Subject: iPad Battery Charger Contacts

An improvement has been made to the iPad Single Battery Charger to improve the reliability and robustness of the contacts within the Charger.

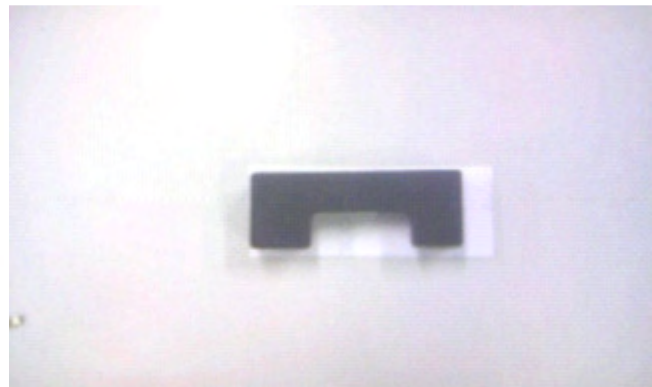
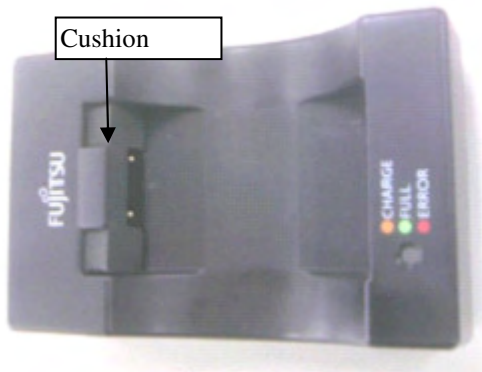
It was found that if the Battery is not inserted into the Charger correctly, the Battery can press sideways on the Contact Pins and cause them to bend or for the contact joints to break resulting in an early failure of the Charger.

A solution has been found where a 'cushion' is added around the charger pins. While simple in appearance, it is a full solution and accomplishes several things:

- Forces the battery into correct position before the pins are contacted.
- Absorbs any extra force that would have previously been applied to the pins.
- Holds the battery more securely in the charger.

- Remove Battery from the Charger
- Unplug power from the Charger
- Peel the adhesive backing from the Cushion
- Install the Cushion so that its top surface is against the top Battery Guide, with adhesive side to the Charger face
 - The notch in the Cushion should surround but not touch the Contact Pins
 - Reference illustration above
- Press the Cushion in place, along the top and both sides
- If this Charger is being returned to stock, reinstall it into its original box and packaging
 - Re-label the outside of the box with the new part number – CA05951-7082
- Done.
